LAND USE APPLICATION COMPLETENESS REVIEW

Subject Property: 1105 Front Street NE

Reference Nos.: 24-106451-PLN (Class 3 Site Plan Review, Tentative Subdivision Plan, Class 1 & 2 Adjustment, Class 2 Driveway Approach Permit)

**TENTATIVE PLAT
 THE CANNERY
 FUND
 SALEM, OREGON**

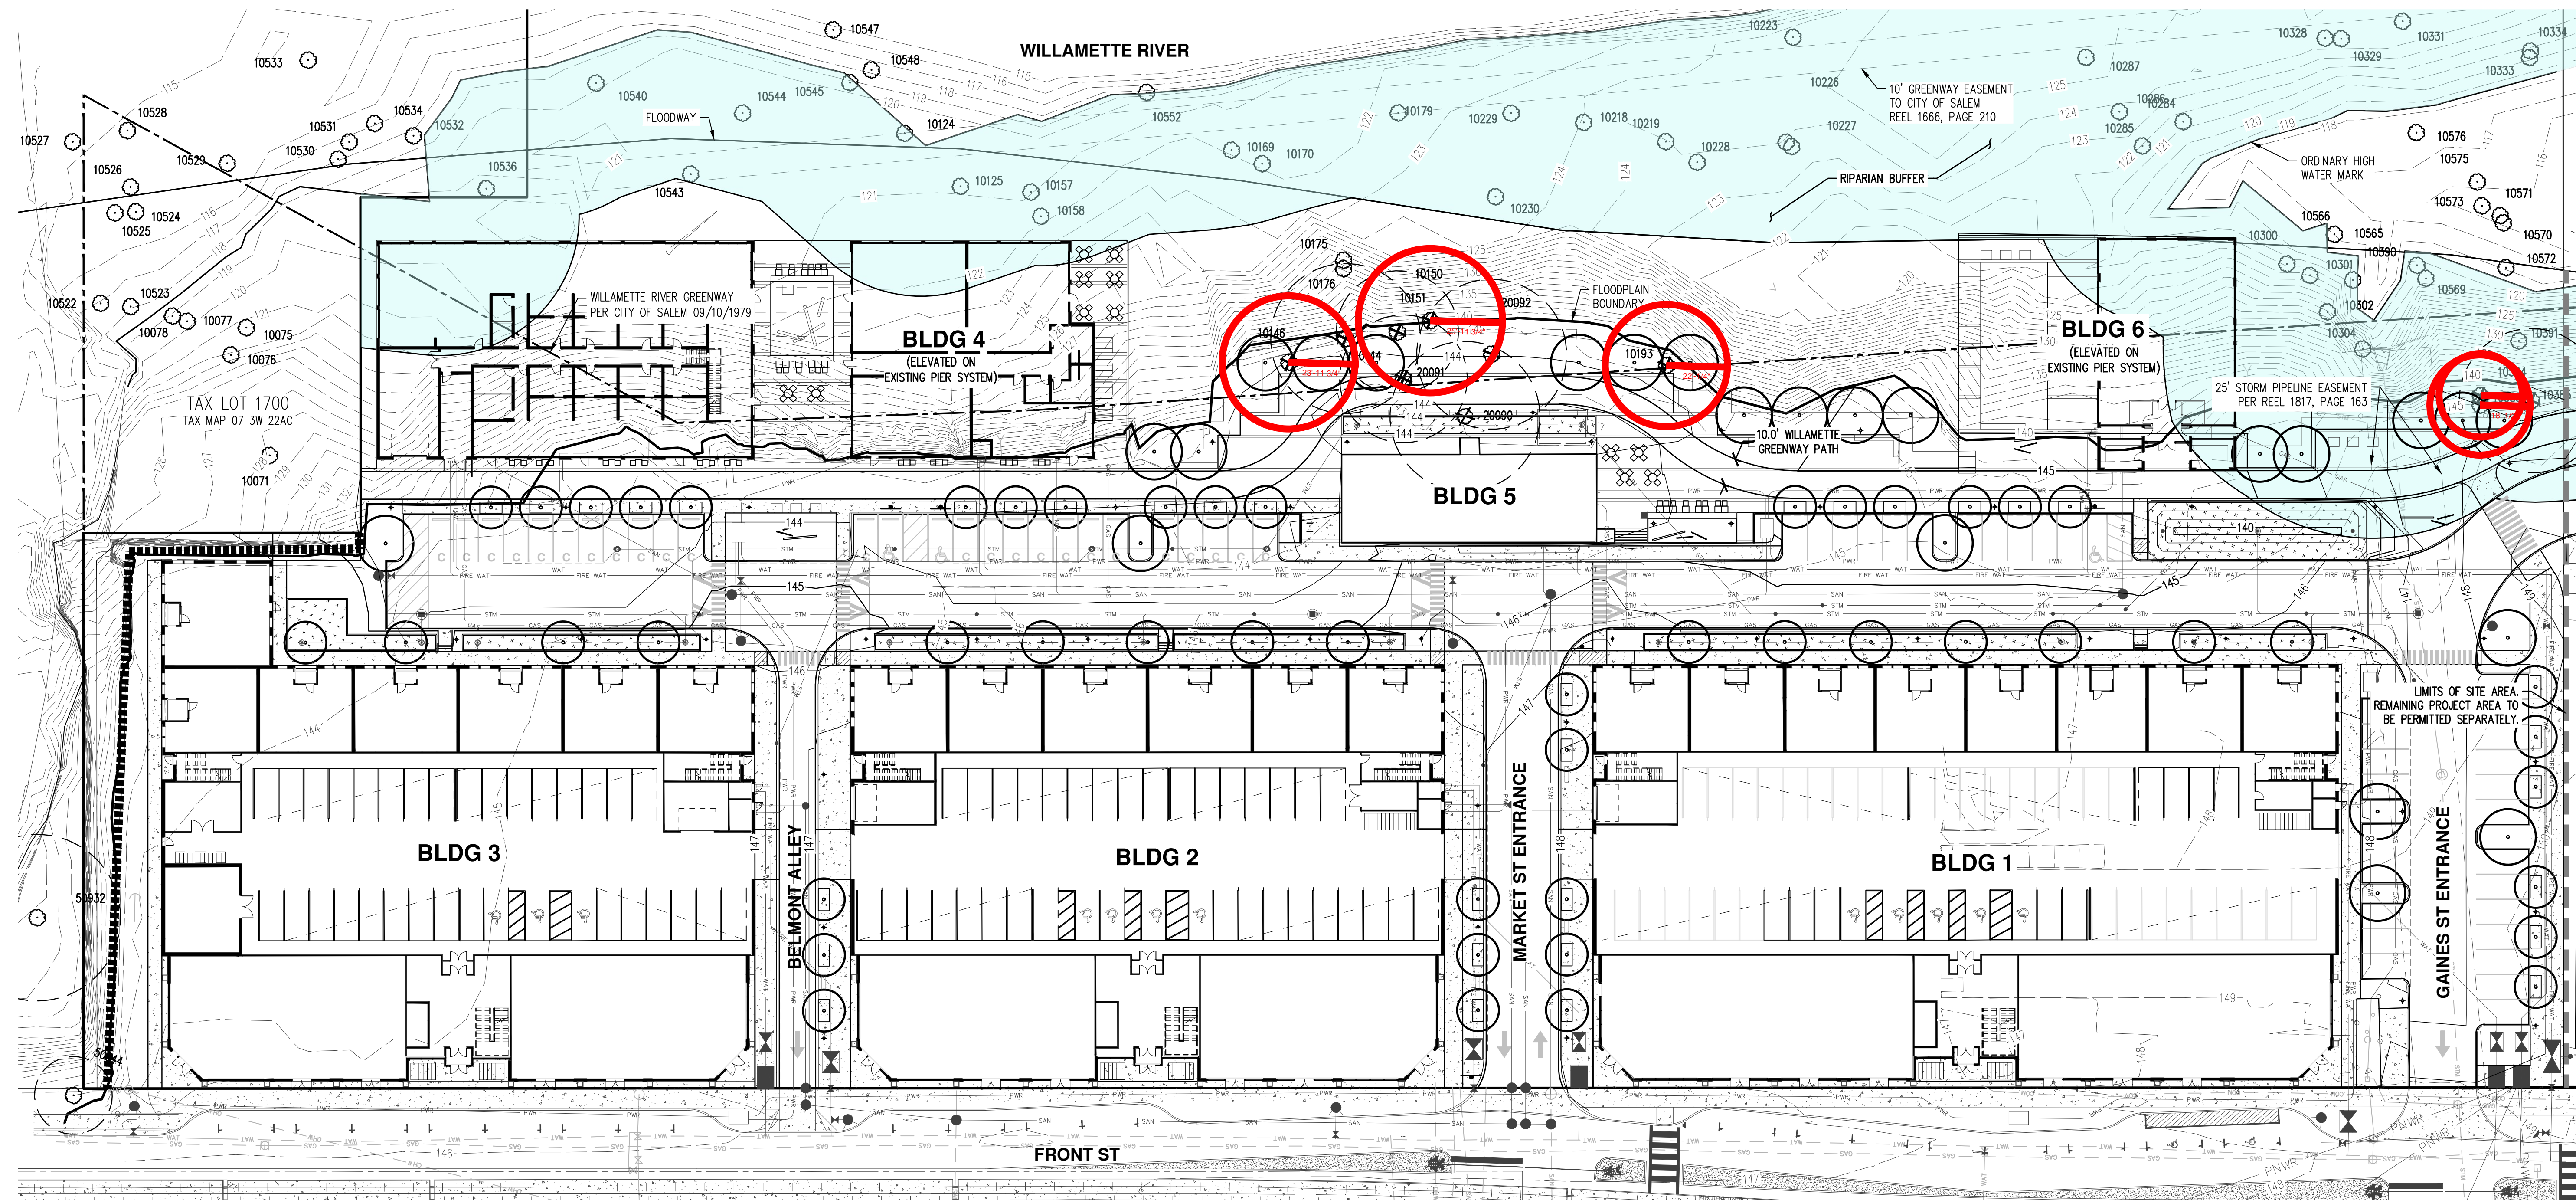
FROM There's a 1-foot reserve strip along this portion of the site. Based on what's shown on the Assessor's map, it appears that the reserve strip extends for a distance of 298.55 ft. along Front Street rather than 278.73 ft.

Willamette Greenway Compatibility Review Boundary:
 -Tentative subdivision plan needs to be revised to also show the Willamette Greenway Compatibility Review Boundary.

PRELIMINARY TREE TABLE
 THE CANNERY
 FUND
 SALEM, OREGON
 PRELIMINARY
 NOT FOR
 CONSTRUCTION

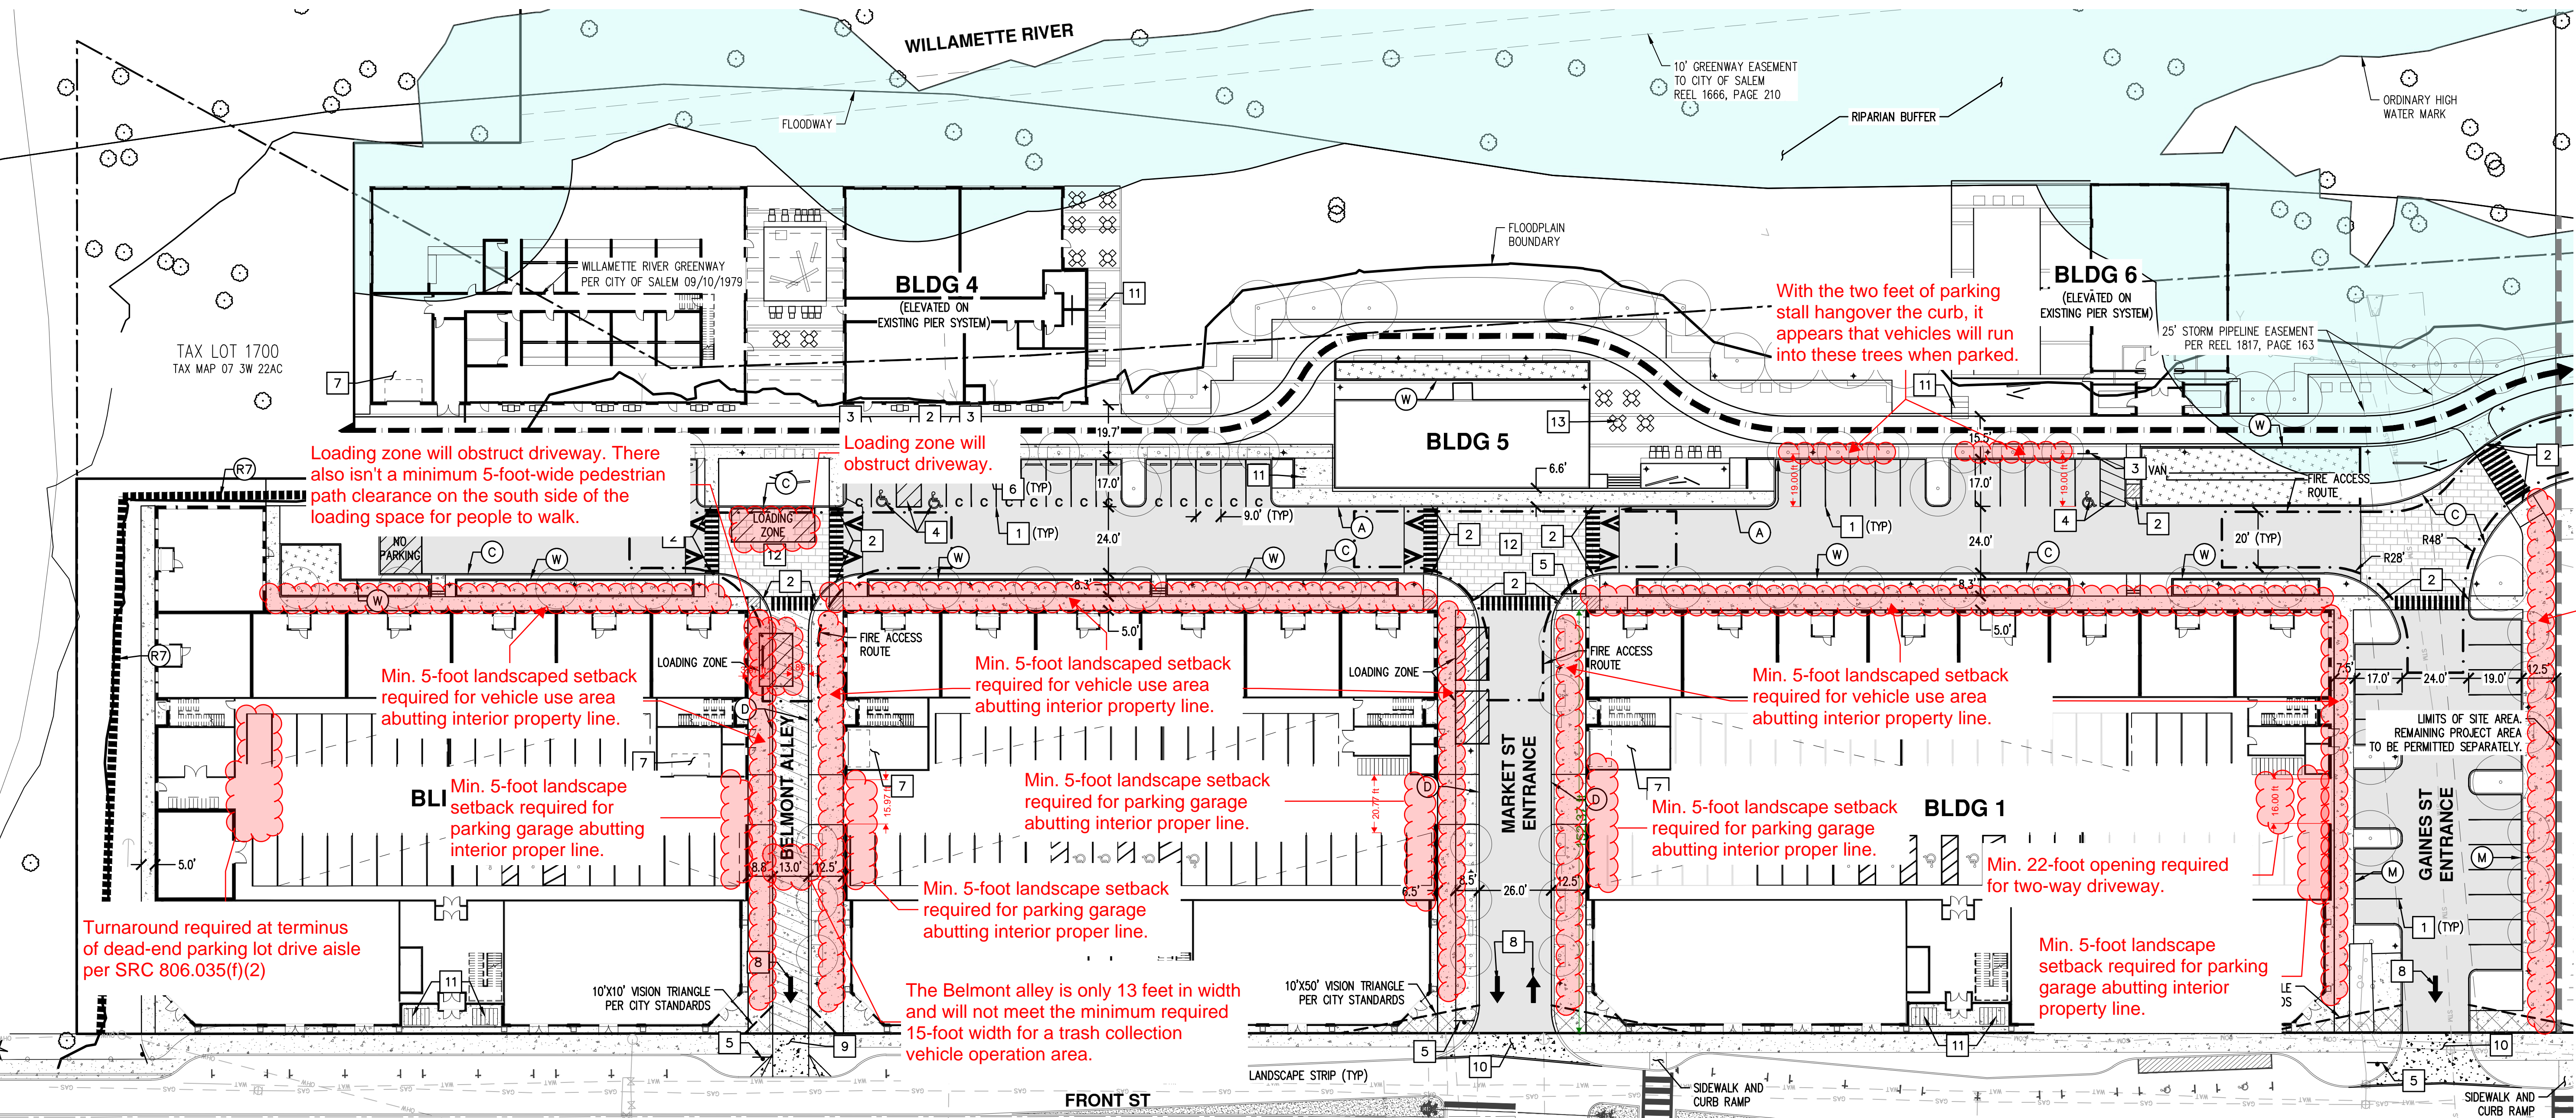
Riparian Corridor Boundaries
 Tree Removal & Preservation Plan needs to be revised to show the 75-foot-wide riparian corridor of the Willamette River and the 50-foot-wide riparian corridor of Mill Creek.

-Tree 10144: Not clear why this tree is proposed for removal. Tree is in good condition with good health rating and good structure rating. It doesn't appear that more than 30% of the critical root zone will be disturbed with the construction of the path.

-Tree 10151: Not clear why this tree is proposed for removal. Tree only has a slight lean and is identified as having a good health rating and good structure rating. It doesn't appear that more than 30% of the critical root zone of this tree will be disturbed with the construction of the path.

-Tree 10193: Not clear why this tree is proposed for removal. Tree is in good condition with good health and good structure rating. It doesn't appear that more than 30% of the critical root zone of this tree will be disturbed with the construction of the path.

-Tree 10383: Not clear why this tree is proposed for removal. Tree not evaluated by arborist but it doesn't look like more than 30% of the critical root zone of the tree will be disturbed with the construction of the path.

-Tree 10384: Not clear why this tree is proposed for removal. Tree not evaluated by arborist but it doesn't look like more than 30% of the critical root zone of the tree will be disturbed with the construction of the path.

SRC 808.030(a)(2)(G) exempts the removal of trees and native vegetation within a riparian corridor from the requirement to obtain a tree removal permit but only when the removal of the tree or native vegetation is necessary for public trail or public park development and maintenance. It doesn't appear, however, that all of the trees identified for removal need to be removed for the construction of the Willamette Greenway path.

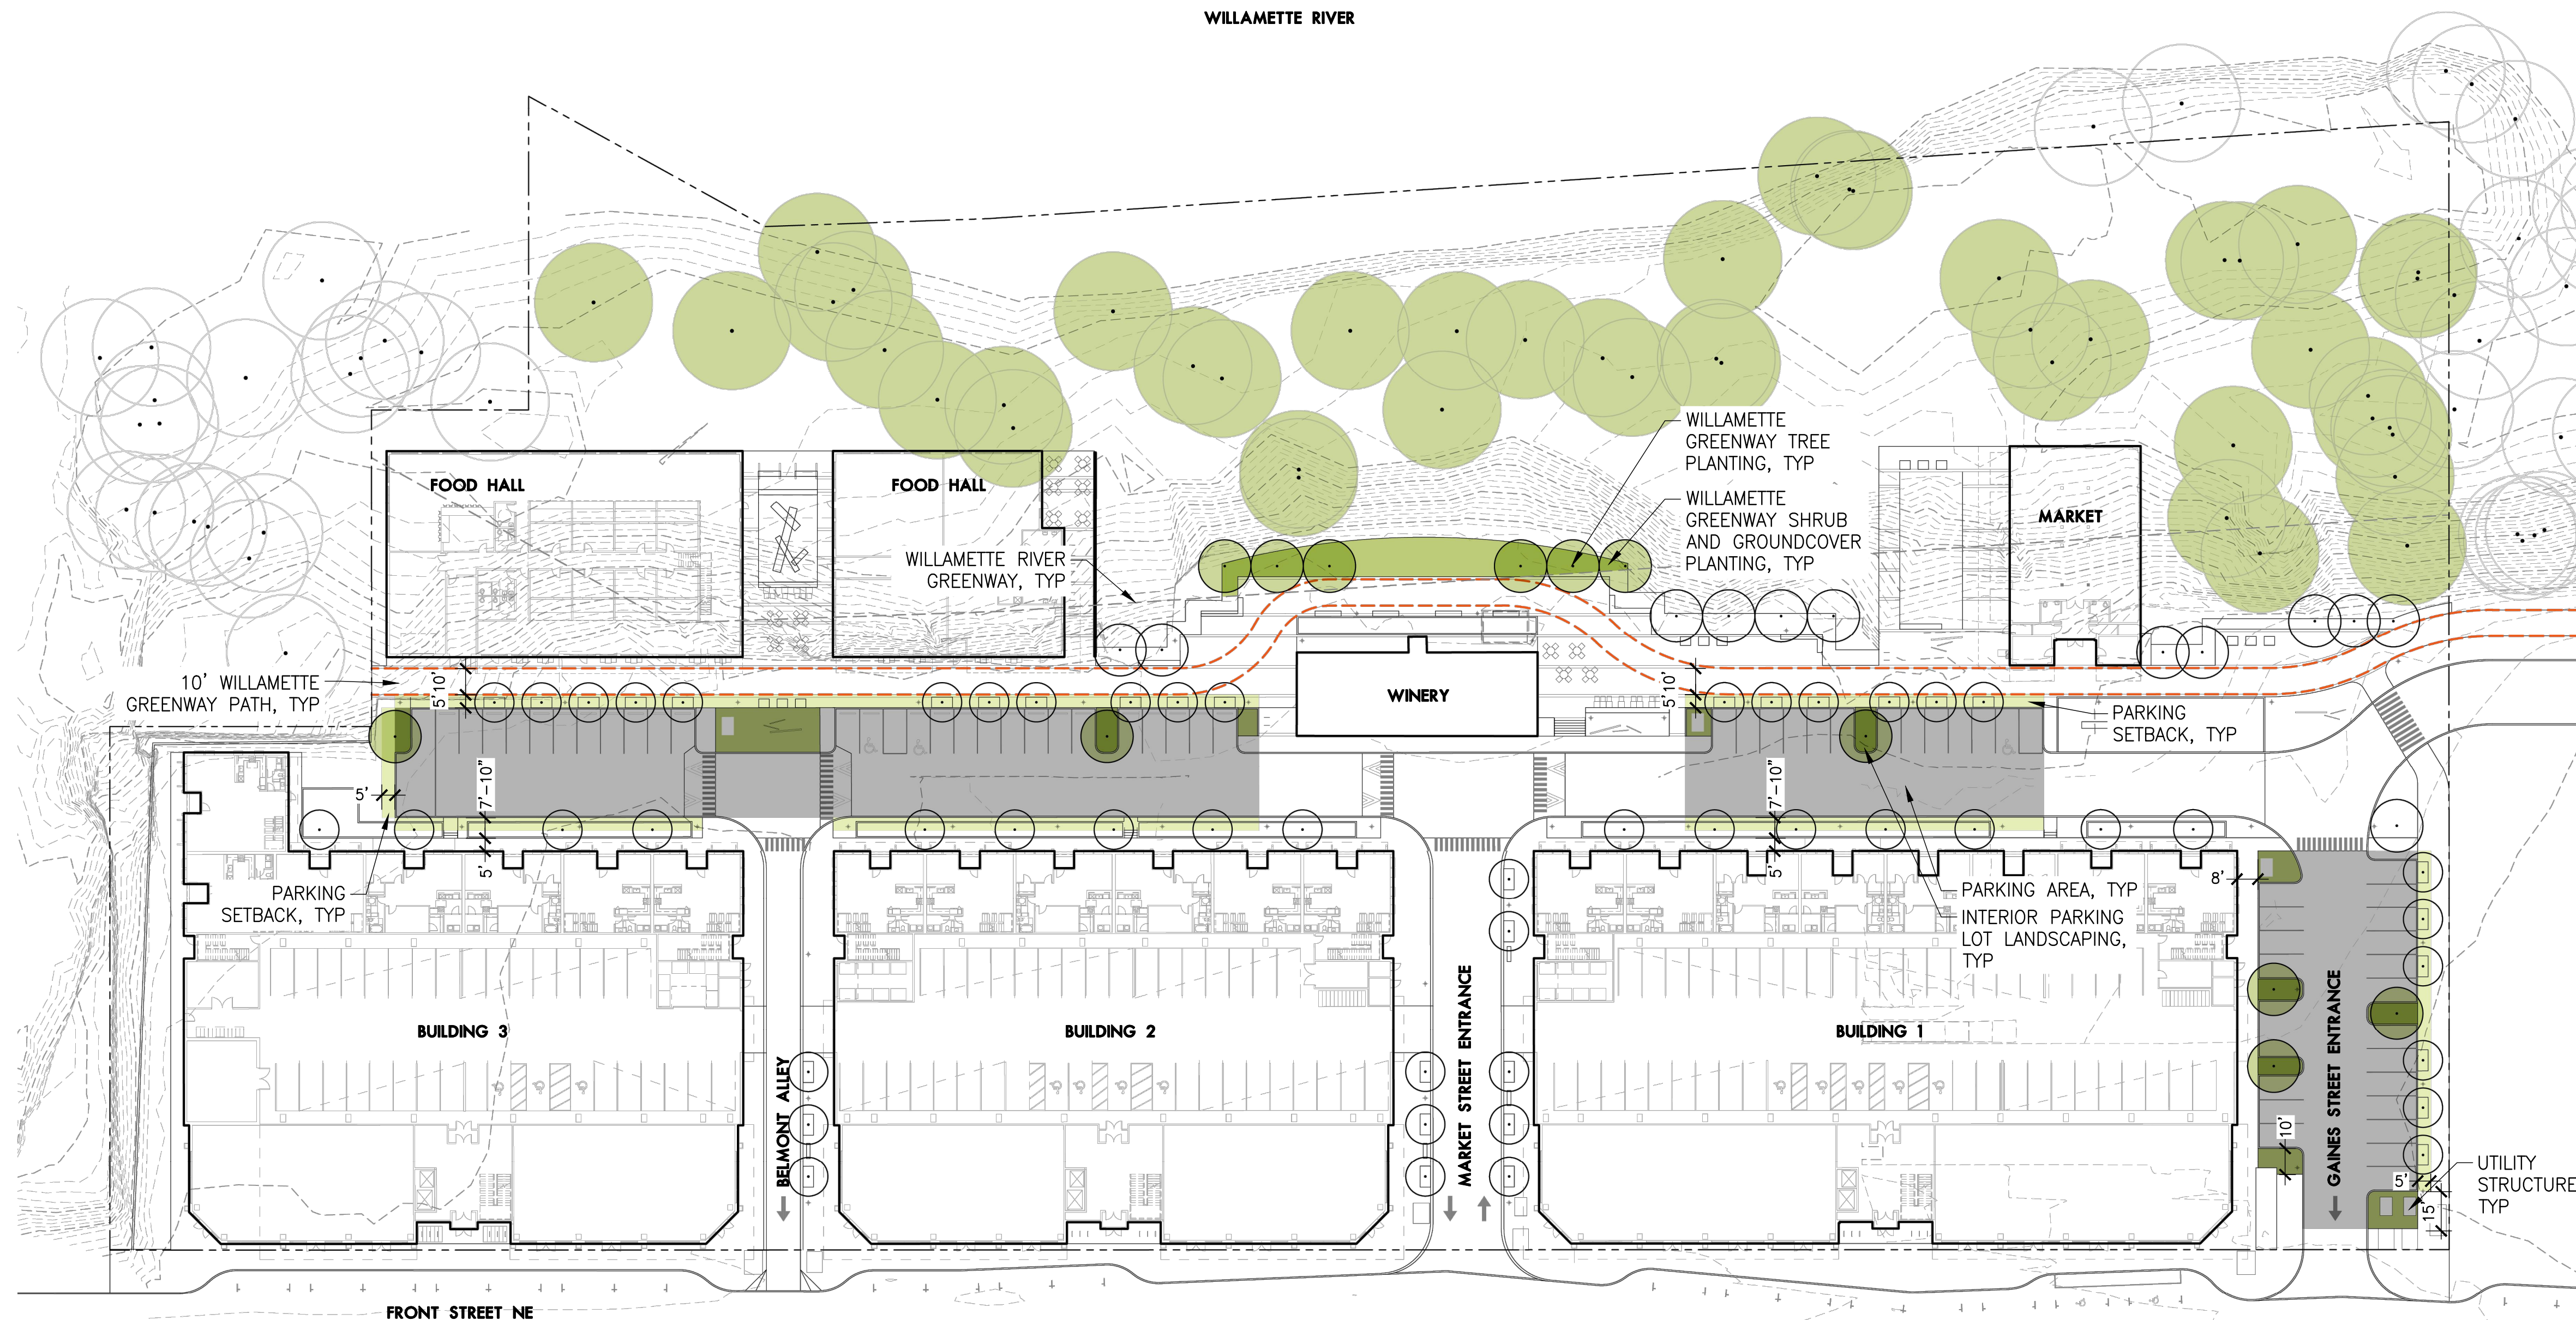
With the two feet of parking stall hangover the curb, it appears that vehicles will run into these trees when parked.

Loading zone will obstruct driveway. There also isn't a minimum 5-foot-wide pedestrian path clearance on the south side of the loading space for people to walk.

Min. 5-foot landscaped setback required for vehicle use area abutting interior property line.

Min. 22-foot opening required for two-way driveway.

Turnaround required at terminus of dead-end parking lot drive aisle per SRC 806.035(f)(2)

The Belmont alley is only 13 feet in width and will not meet the minimum required 15-foot width for a trash collection vehicle operation area.

Willamette Greenway Compatibility Review Boundary:
 -Site plan needs to be revised to also show the Willamette Greenway Compatibility Review Boundary.

Proposed Subdivision Lot Lines:
 -Site plan needs to be revised to clearly show the proposed new subdivision lot lines. The proposed lot lines are very difficult to distinguish on the plan due to their color being black. A different color is recommended so the proposed lot lines can be clearly seen in relation to the the building and site improvements.
